# *LEAF APARTMENTS*

**SE DESIGN REVIEW BOARD**

**RECOMMENDATION MEETING #2**

DPD # 3018098

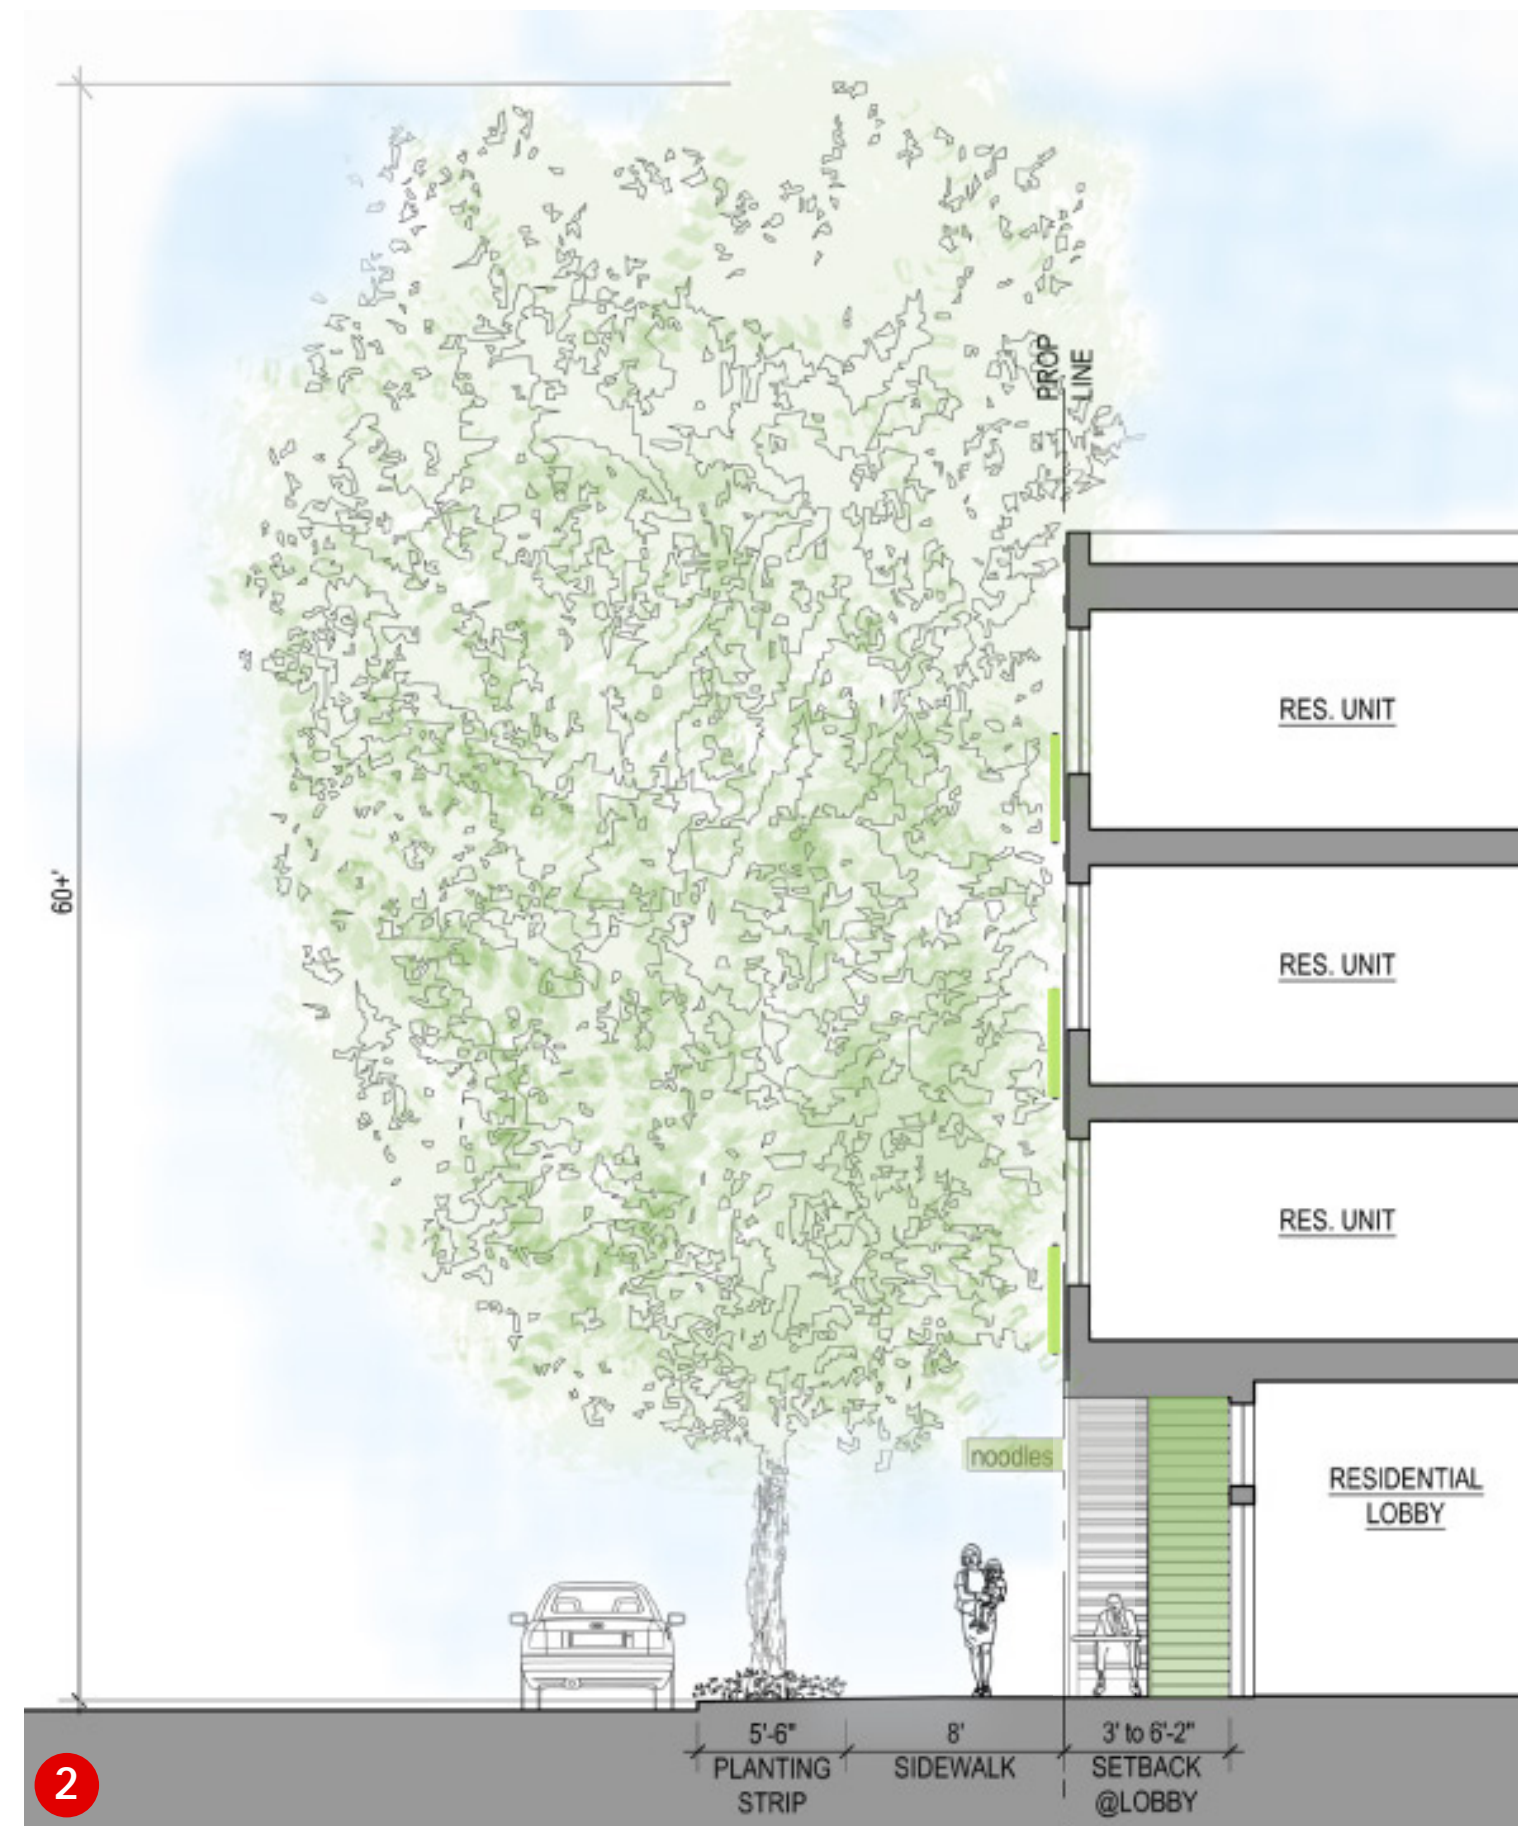
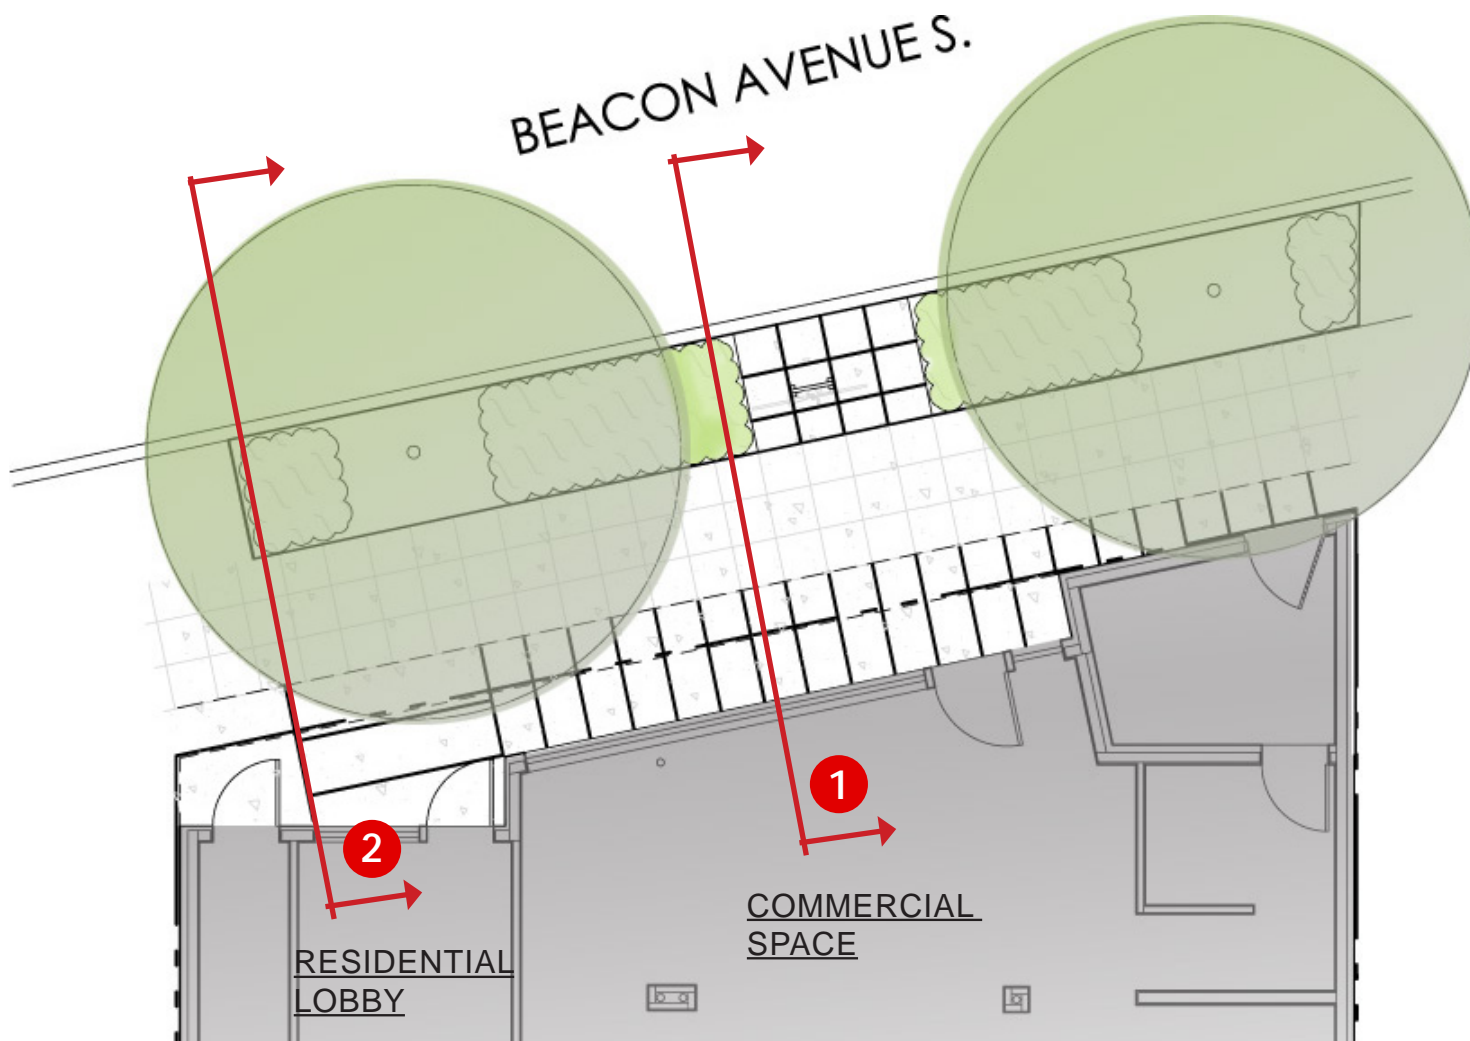
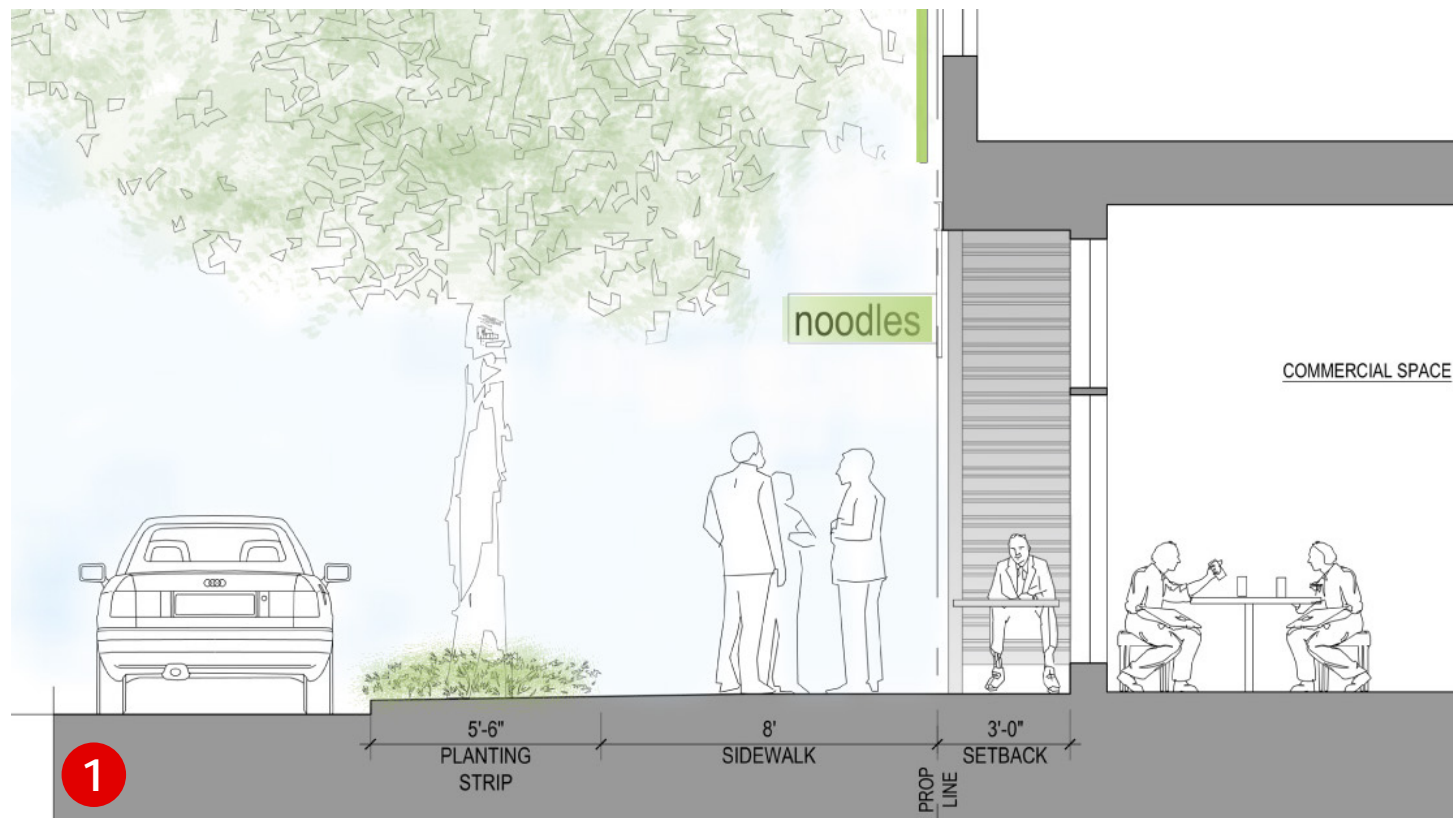
- The Board agreed the two ENTRANCES SHOULD BE FURTHER DISTINGUISHED such that each is OBVIOUS AND CLEARLY IDENTIFIABLE as a COMMERCIAL or RESIDENTIAL entry

- The Board requested SIDEWALK WIDTH and STREET TREE DETAILS be included

## COMMERCIAL ENTRY

- 3' SETBACK TO PROVIDE OUTDOOR SEATING
- ANODIZED ALUMINUM STOREFRONT
- GREY (ZACTIQUE II) BOX RIB METAL
- BLADE SIGNAGE PERPENDICULAR TO FACADE

## RESIDENTIAL ENTRY

- 3'-6' SETBACK
- GREEN STOREFRONT
- GREEN STAINED CONCRETE TILE

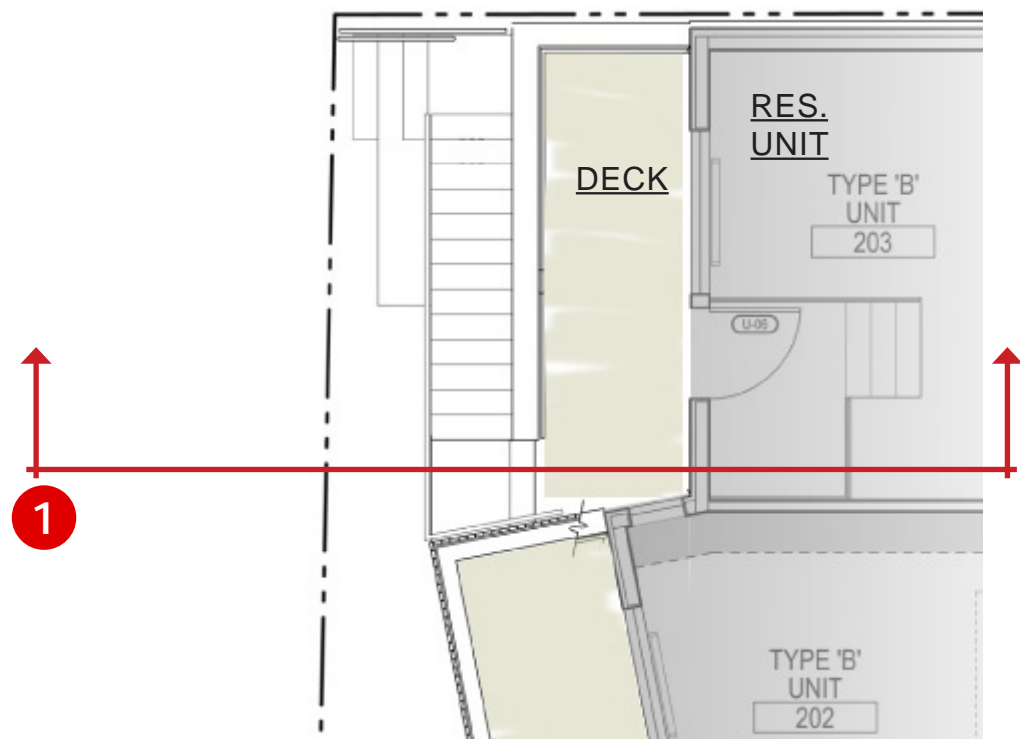
- The Board expressed concern that the street-level facade better respond to the neighborhood context by providing a **STRONGER CONNECTION TO THE STREET**
- The Board directed the applicant to **INCREASE THE AMOUNT OF TRANSPARENCY** along the street-level facade along Alamo PL S
- Some members of the Board **QUESTIONED THE NECESSITY OF THE PRIVATE STAIRCASE** and whether more landscape could be provided.

## TRANSPARENCY

- ADDED WINDOW INTO BIKE ROOM
- ADDED TRANSPARENT PANEL TO GARAGE DOOR
- RAISED HEIGHT OF DOOR AND WINDOW AT RESIDENTIAL ENTRY
- INCREASED TRANSPARENCY FROM 19% TO 30%

## CONNECTION TO THE STREET

- **PRIVATE ENTRY STOOP/STAIR/BENCH TO 2ND FLOOR UNIT \***
  - ACTIVATES the street edge by promoting human activity
  - ADDS VISUAL INTEREST to the street edge
  - ERODES the massing at NW corner adjacent to neighboring living units
  - RESPONDS TO NEIGHBORHOOD CONTEXT of single & multi family buildings with stoops
  - provides a UNIQUE LIVING UNIT
- EYES ON STREET PORCHES AT LEVEL 2
- LANDSCAPING RELATES TO SINGLE FAMILY RESIDENTIAL PATTERN AND CHARACTER OF ALAMO PL S
- CLEARLY IDENTIFIABLE RESIDENTIAL ENTRY WITH LARGE STOREFRONT WINDOW

PARTIAL PLAN - LEVEL 2

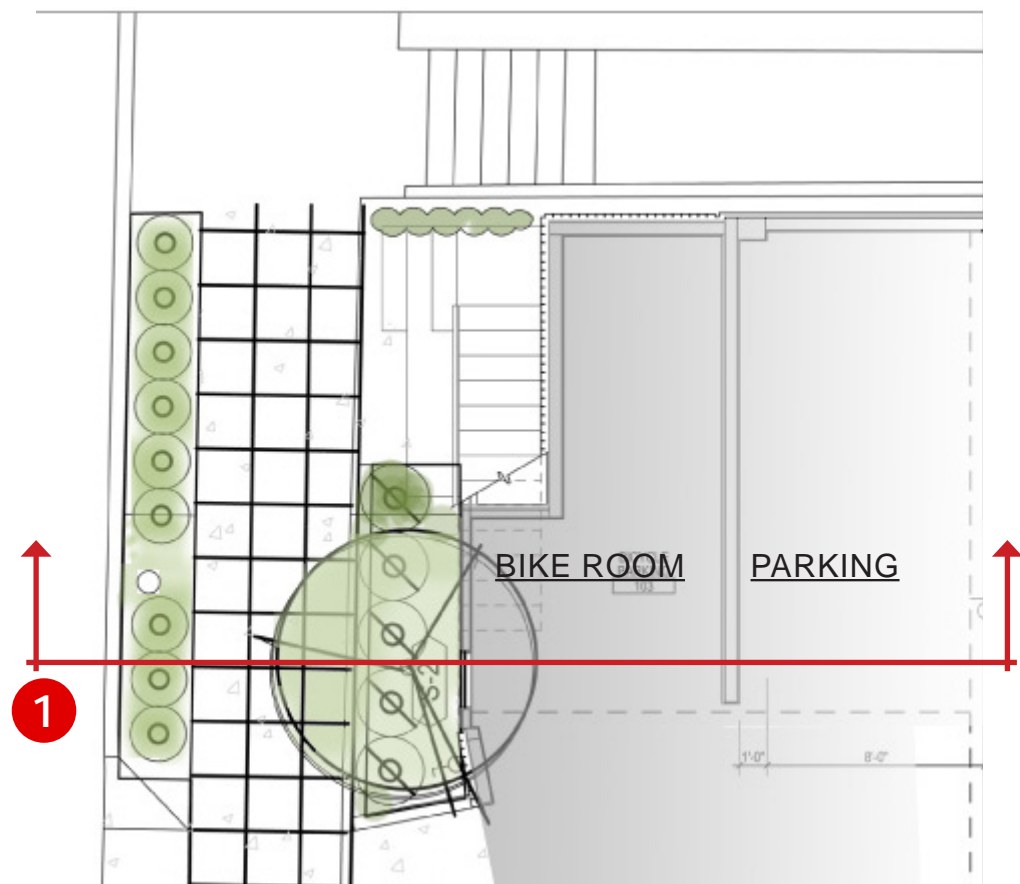
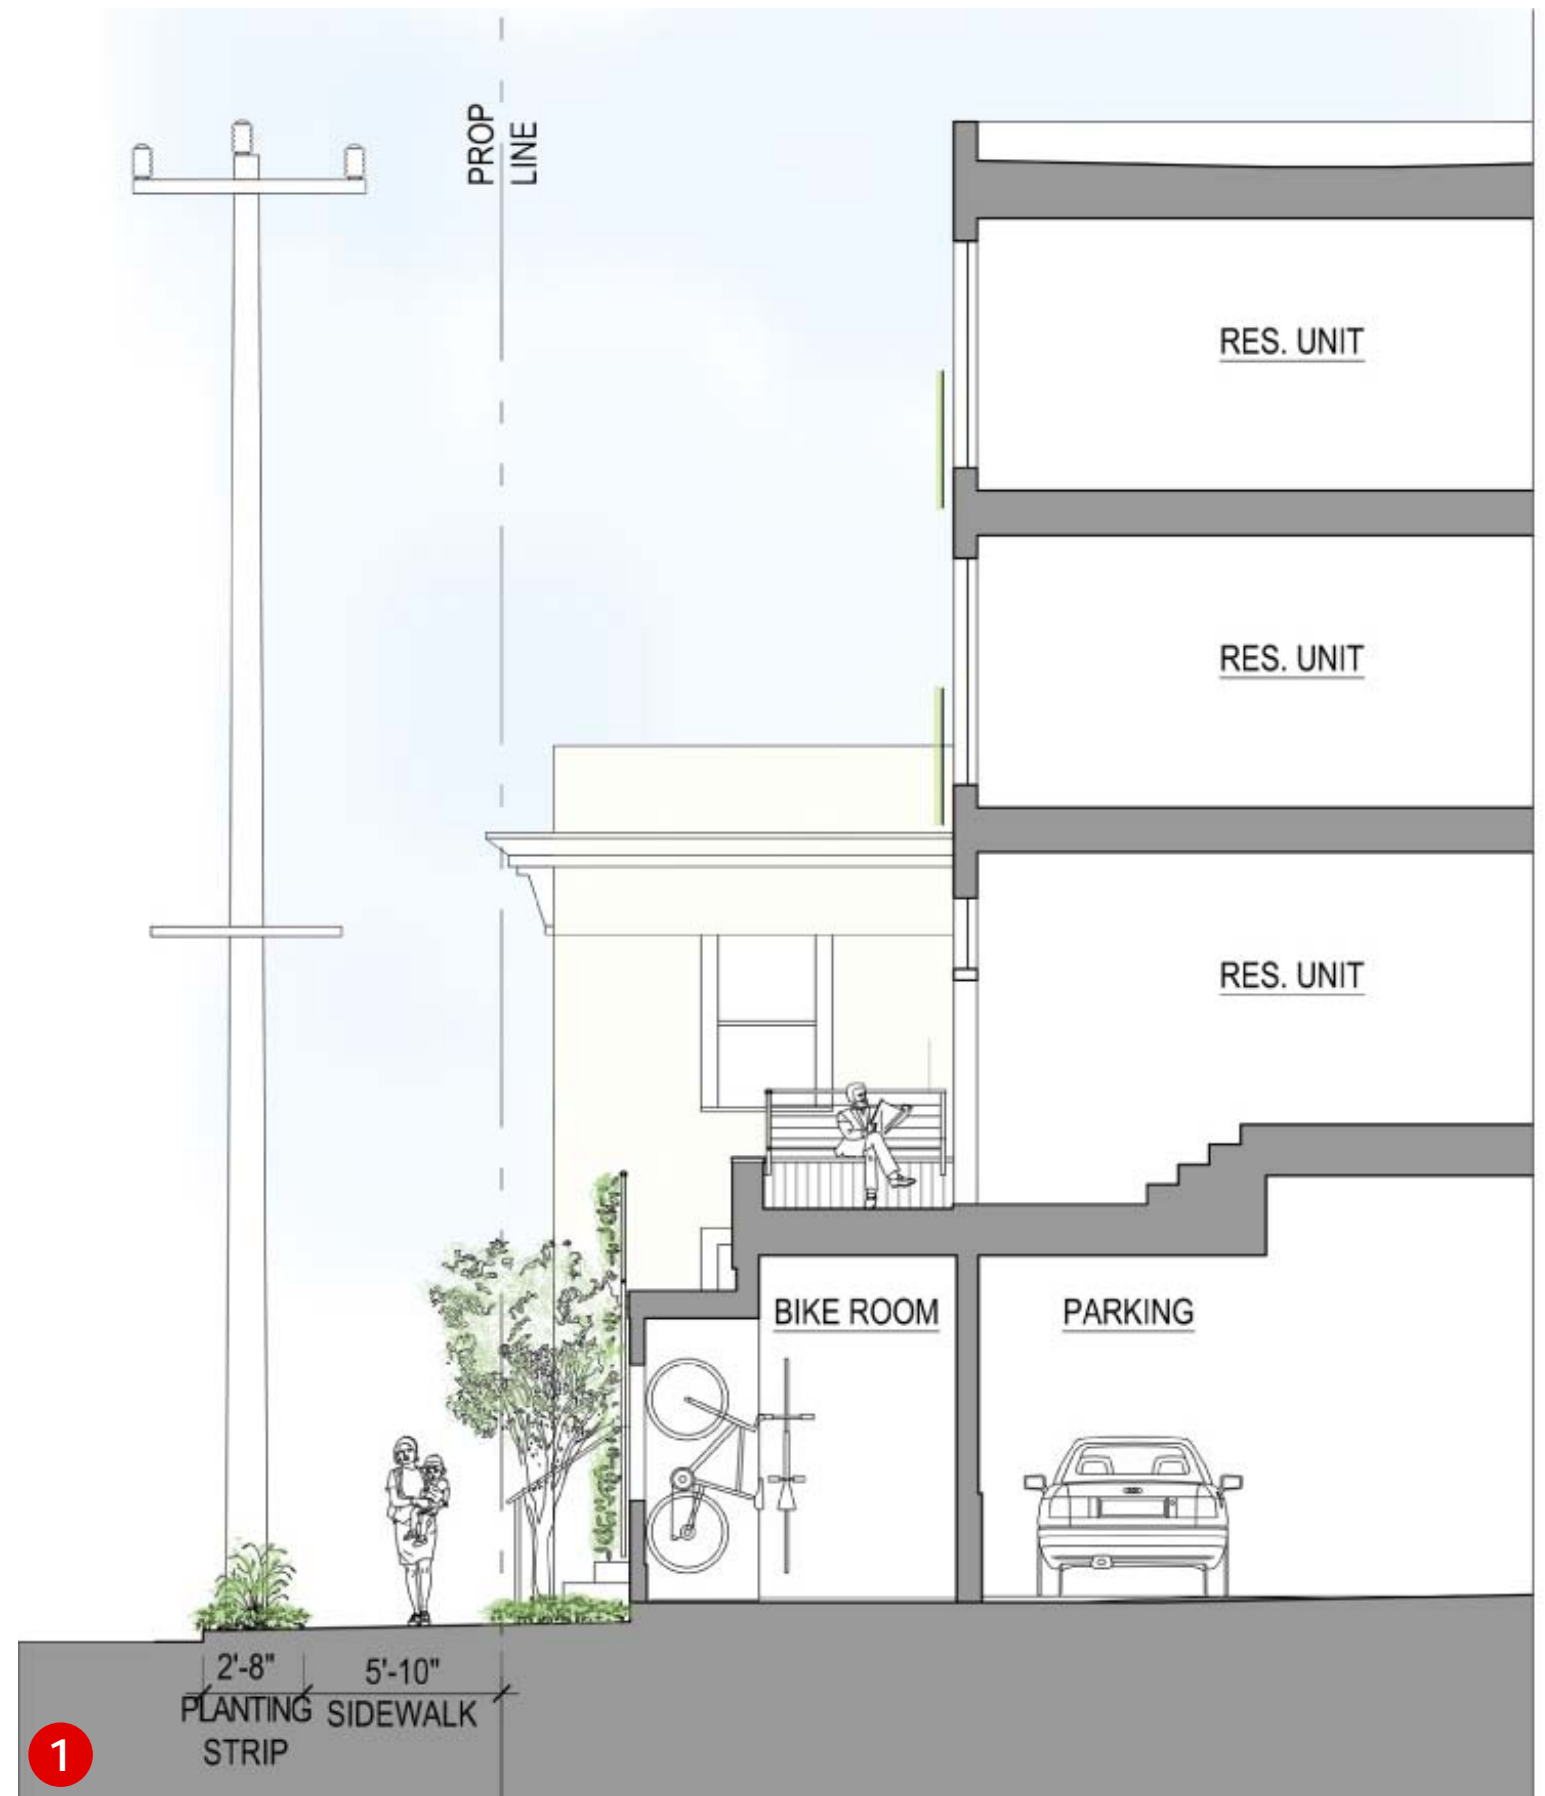
- Some members of the Board QUESTIONED THE NECESSITY OF THE PRIVATE STAIRCASE and whether more landscape could be provided.

## PRIVATE STAIRCASE TO 2ND FLOOR UNIT

- *ACTIVATES the street edge by promoting human activity*
- *ERODES the massing at NW corner adjacent to neighboring living units*
- *ADDS VISUAL INTEREST to the street edge*
- *RESPONDS TO NEIGHBORHOOD CONTEXT of single & multi family buildings with stoops*
- *provides a UNIQUE AND DESIRABLE LIVING UNIT*
- *CONNECTION TO THE STREET*
